Service Information

AWZ 10HP UK

8599 915 45230

Spare Part List	2
Exploded View	4
Technical Data	6
Wiring Diagram	9
Circuit Diagram	11
Testprogram	13
Error Codes	16
Service Bulletin 4812 713 40361	17
Service Bulletin 4812 713 40332	19
Service Bulletin 4812 713 40364	20
Service Bulletin 4812 713 40373	24
Service Bulletin 4812 713 40342	25
Service Bulletin 4812 713 40349	26

TITLE: How to replace the belt

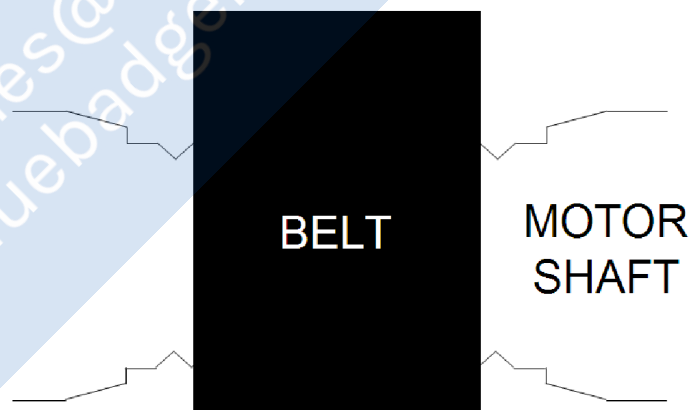
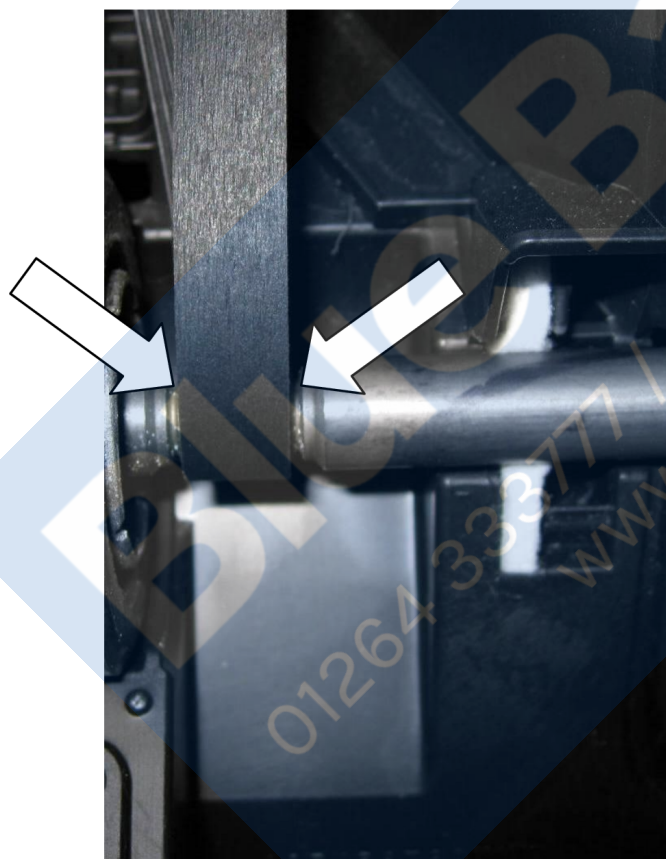
SUBJECT: Correct position of the belt on motor pulley

In order to avoid that the belt will be damaged, it is strongly requested to set the belt in the right position on the motor pulley.

The normal setting is to place the belt on the **middle** of the 9 grooves of motor pulley as shown on the picture below.

Important: Turn the drum three times in CW and three times CCW direction and check again the correct position of the belt!

S:05 Temperature increase dependent on time

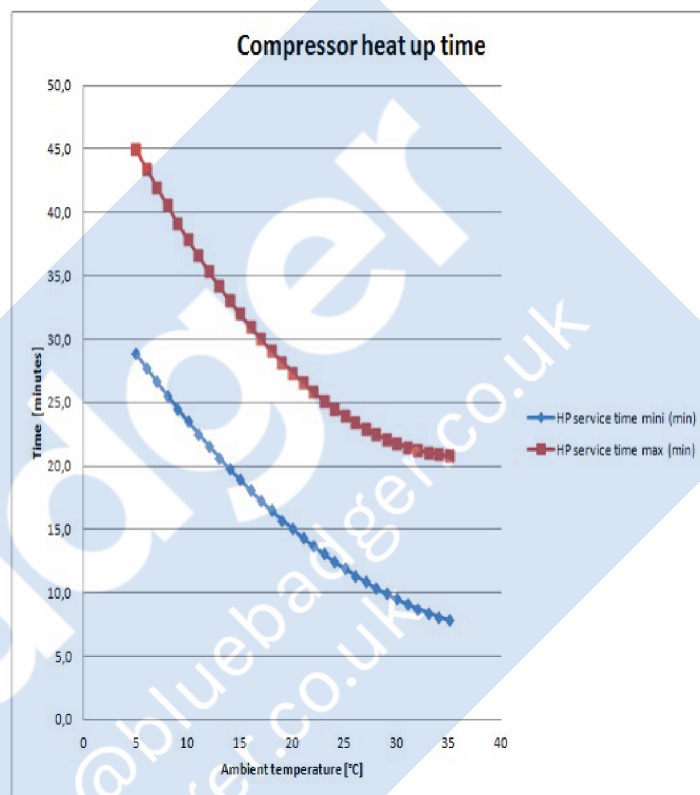
SUBJECT: Check heating phase of the compressor

If customer claim a bad drying result or bad performance of the heat pump dryer always execute the service test program. In step S:05 the compressor will be tested in 2 steps. Refer to the section test program in the Service Information with respect to the different temperatures which should be reached for A+, A++ and A+++, see also graph here below.

Short: After 2 minutes the buzzer give a sound for 30 sec. = okay; F23 = fails

Long: Stop the time how long it's take to reach the max. operating temperature, see table below.

For the test respect the environment temperature. If the dryer is placed in a cold environment it will take much more time to reach the max. operating temperature.

Spare part code 481010560208

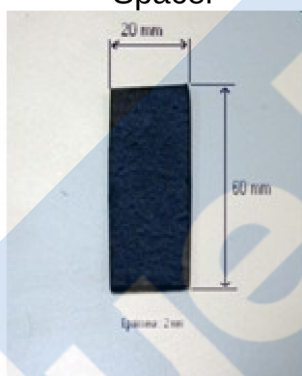
Service Bulletin 4812 713 40349**AUTHOR:** Kay Augustin**Last Update:** 23/05/18**VERSION:** 1.0**TITLE:** Interference between Blower Wheel and Housing**SUBJECT:** Due to small variations on the execution of bottom base and motor blower it is possible to have a mechanical interference between the blower wheel and cover base.**REMEDIAL ACTION**

In case of interference which can create a scraping noise, check the gap between blower wheel and cover base on top right side. If the blower is touching or if the gap is below 1mm the product needs to be reworked as follow:

Remove the motor and add the Spacer 481010560208 to the base under the right motor silent block.
